From: Bill Webster, Assistant Director of Parks and Recreation

Date: July 24, 2013

Subject: Southern Area Greenways Overview and Obey Creek Comments

MAP 4.7 - MORGAN CREEK

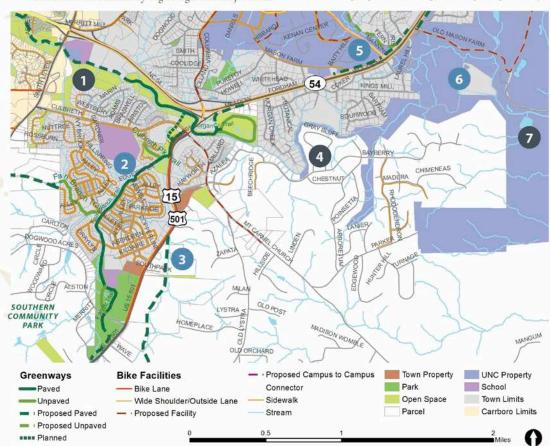
The next phase of the trail would take it to Smith Level Road and a future connection with Carrboro's Morgan Trail. This section will be challenging in many ways. It will have to address a creek crossing, significant private property, an underpass of Smith Level Road and steep slopes. At this time here are no funds for planning and design. At this time we no schedule.
